Modification Recommended Service Note

N9030B X-Series Signal Analyzer

The Problem
Signal amplitude loss can occur above 3.6 GHz tuned frequency on option 544 (44 GHz) or option 550 (50 GHz) analyzers.

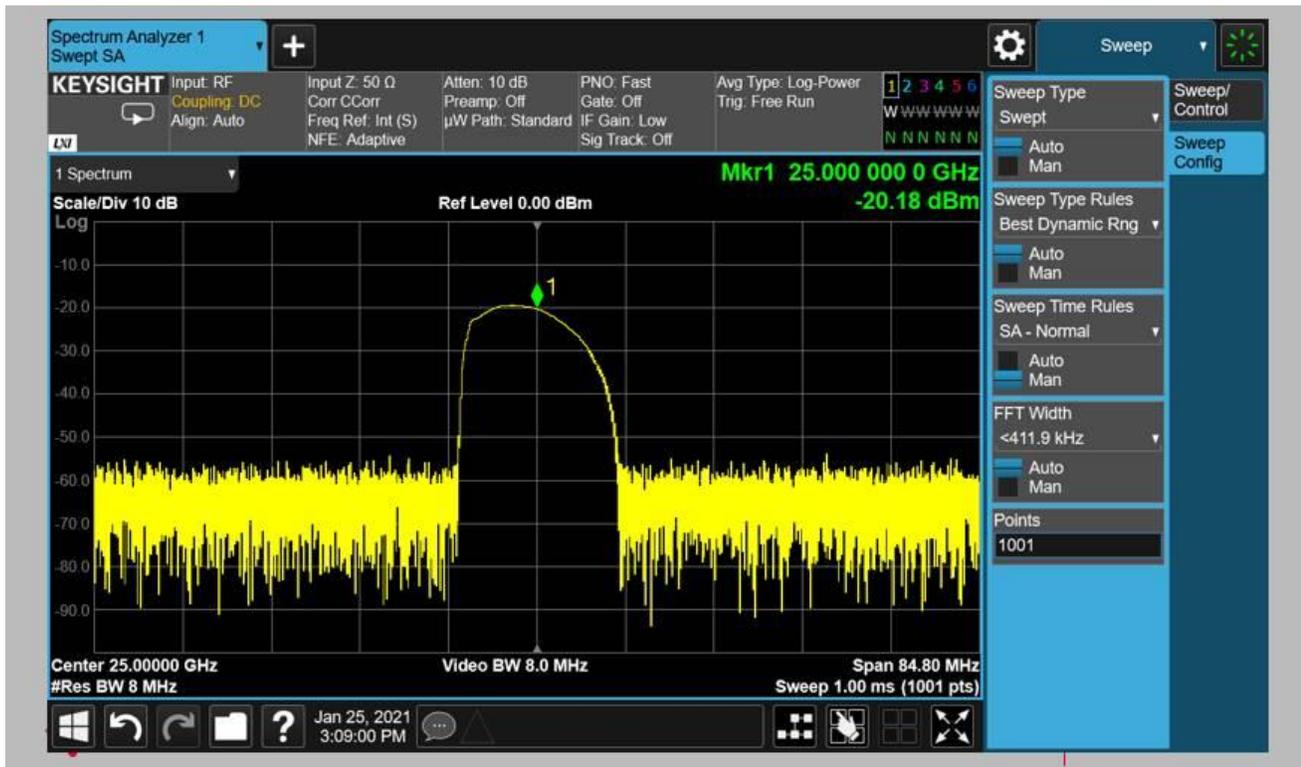
If you want to verify the problem, set up the analyzer as shown in this screen shot. A 25 GHz signal at -15 dBm is provided by a signal source. Notice the signal is distorted, and the amplitude is 5 dB lower than expected.

Action 1.
1. Download and install instrument software A.28.07 or later. This software version ignores the calibration values on the instrument disk image that cause the issue.
2. Perform the built-in Characterize Preselector routine.
    Press **System** (the gear icon in the upper right portion of the instrument screen), **Alignments**, **Advanced**, **Characterize Preselector**.

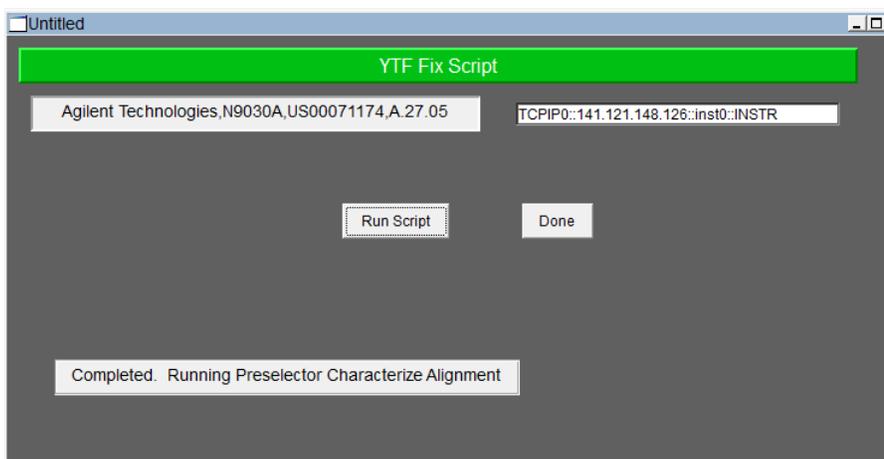
Carefully enter the instrument's VISA address into the upper right box and click Run Script.
For example, if an instrument is connected to a common LAN router with an external PC, then the VISA address would be in the format of: TCPIP0::192.168.0.2::inst0::INSTR, where 192.168.0.2 is the instrument's IP address.
The utility will complete the changes to the instrument's disk image and then perform the Characterize Preselector routine that takes a few minutes.
